FINAL PLAT
PIZZA HUT PAWNEE/HYDRAULIC ADDITION
AN ADDITION TO WICHITA, SEDGWICK COUNTY, KANSAS

RE: SUB 2000-60 -- One-Step Final Plat of PIZZA HUT PAWNEE/HYDRAULIC ADDITION

At the regular meeting of the Subdivision Committee of the Metropolitan Area Planning Commission on Thursday, August 10, 2000, the above captioned plat was considered. The action of the Committee was to approve the final plat, subject to the following:

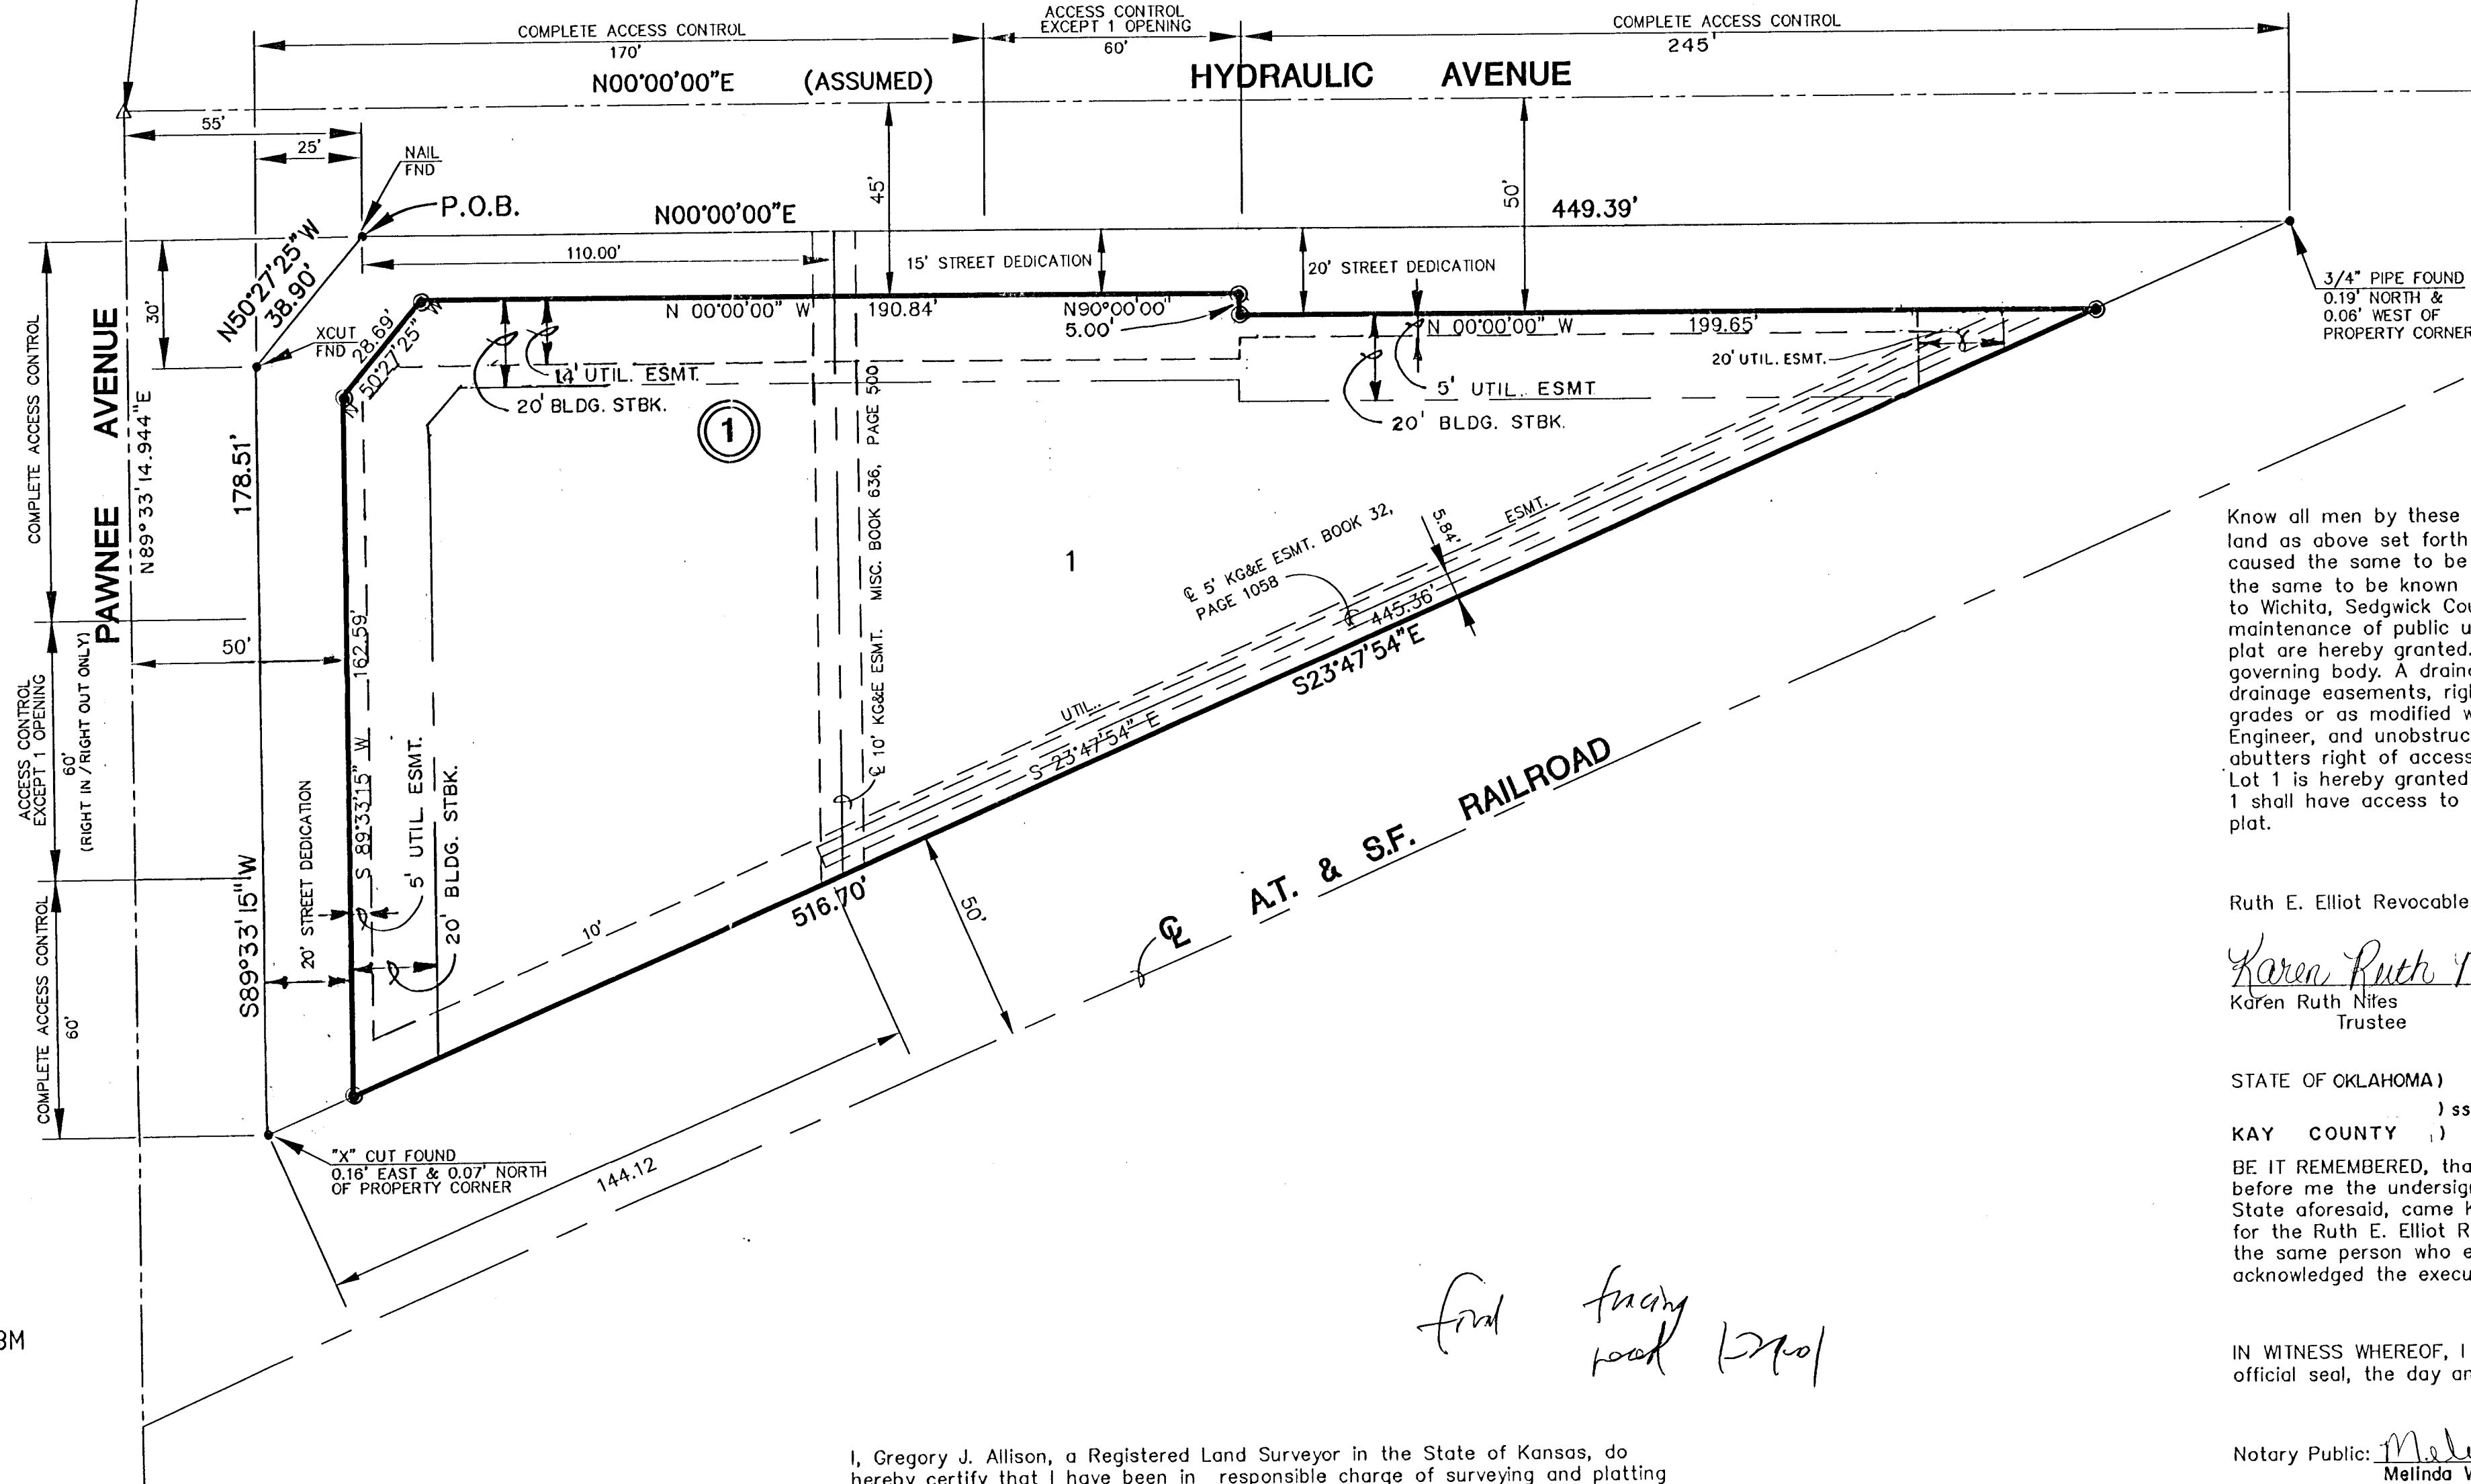
- A. Municipal water and sanitary sewer services are available to serve the site. City Engineering needs to comment on the need for any guarantees or easements. A 20-ft wide easement will need to be platted to cover the existing east-west sanitary sewer line across the northern portion of the site. A temporary easement is needed to cover the sewer line running parallel with the east line of the plat until its removal.

- D. City Engineering needs to comment on the status of the applicant's drainage plan. A revised drainage plan needs to be submitted. As some of the site's drainage is directed onto the adjacent railroad right-of-way, a letter shall be provided from that railroad indicating their willingness to accept such drainage.

- E. Traffic Engineering needs to comment on the access controls. The plat proposes three access openings along Hydraulic and two access openings along Pawnee. 150 feet of complete access control is required from the intersection and from the nearest railroad track. This will necessitate a modification from the Subdivision Committee. Distances should be shown for all segments of access control. The final plat tracing shall reference the access controls in the plat's text. Traffic Engineering has approved one opening along Hydraulic (full turning movements) and one opening along Pawnee (right turns only). The Subdivision Committee has approved a modification of the required complete access control along Pawnee.

- F. **Traffic Engineering** needs to comment on the need for additional right-of-way along Hydraulic and Pawnee. *The Applicant shall dedicate 50-ft of half street right-of-way along the northern 245 feet of the plat's frontage along Hydraulic, 45-ft of half-street right-of-way along the remainder of Hydraulic, 50 feet of half-street right-of-way along the corner clip, and 50 feet of half street right-of-way along Pawnee.*

- H. The owner's name "Noles" on the signature block needs to be corrected to "Niles" as referenced in the platting binder.
- I. The Deputy County Surveyor has advised that the plat boundary does not close.

- J. The "utility setback" along the south needs changed to a "utility easement".
- K. The width of the KGE easement in Book 32, Page 1058 needs to be denoted, along with the location of the south end of the easement.

- L. On the Benchmark, both C's need changed to Centerline.
- M. The legend needs changed from "=I.P." to "=found monument".
- N. Based upon the platting binder, property taxes are still outstanding. Before the plat is scheduled for City Council consideration, proof shall be provided indicating that all applicable property taxes have been paid.

- O. The platlor's text shall include language that a drainage plan has been developed for the plat and that all drainage easements, rights-of-way, or reserves shall remain at established grades or as modified with the approval of the applicable City or County Engineer, and unobstructed to allow for the conveyance of stormwater.

- W. The representatives from the utility companies should be prepared to comment on the need for any additional utility easements to be platted on this property. Southwestern Bell requests a 10-ft utility easement along the eastern line of the plat.
